ADDENDUM NO. 2

ZOO MAINTENANCE BUILDING
PROJECT PR-L-2824

CITY OF MARSHFIELD

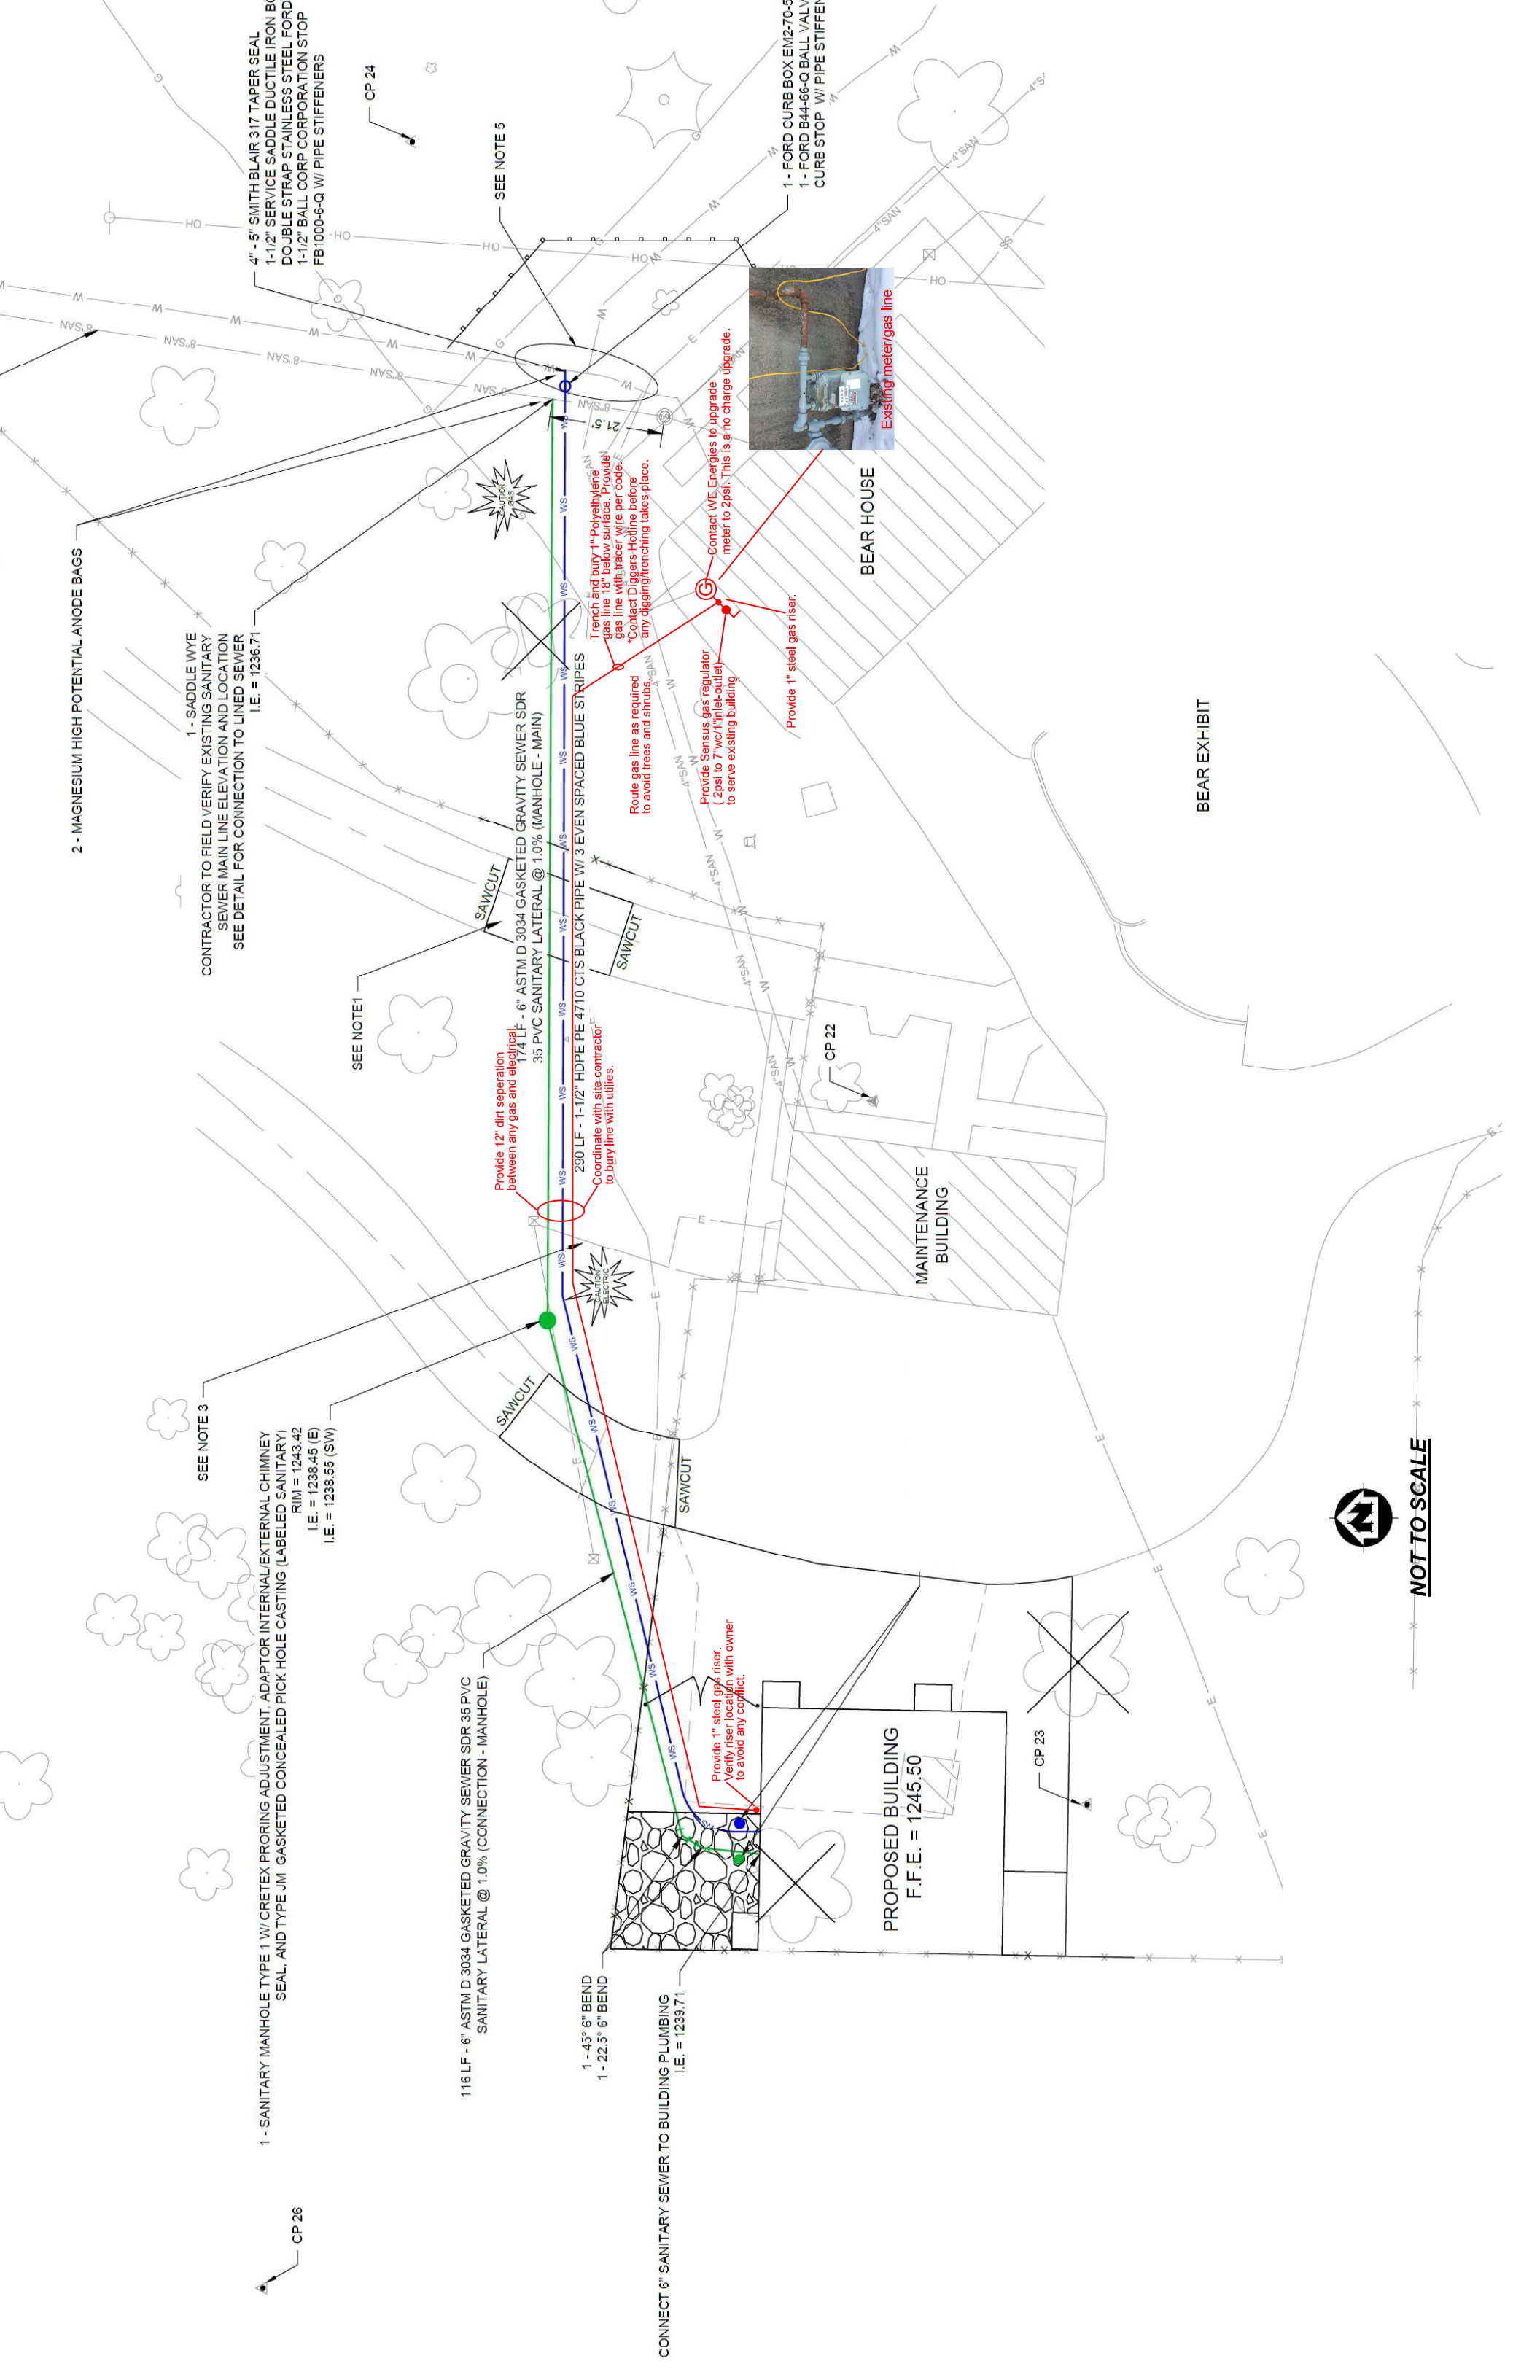
1. Gas Service To Building

The CONTRACTOR shall include the furnishing of all labor, materials, services, and equipment necessary for and incidental to all gas work required as shown on the plans and noted in these specifications. The CONTRACTOR shall provide all labor, material, equipment and services to construct and install gas service to the building. The CONTRACTOR shall do all trenching, tunneling, backfilling, restoration, cutting, patching and other items required for a complete installation. NOTE - the CONTRACTOR will cross existing electrical wiring. Any damage that occurs to the existing wiring is to be repaired by the CONTRACTOR, with all material, labor, and equipment costs to repair or replace existing wiring to be the responsibility of the CONTRACTOR. The CONTRACTOR shall provide a complete schedule of materials and equipment for installation shall be submitted to the OWNER before purchasing materials and equipment.

Please note attached drawing for gas service to building.
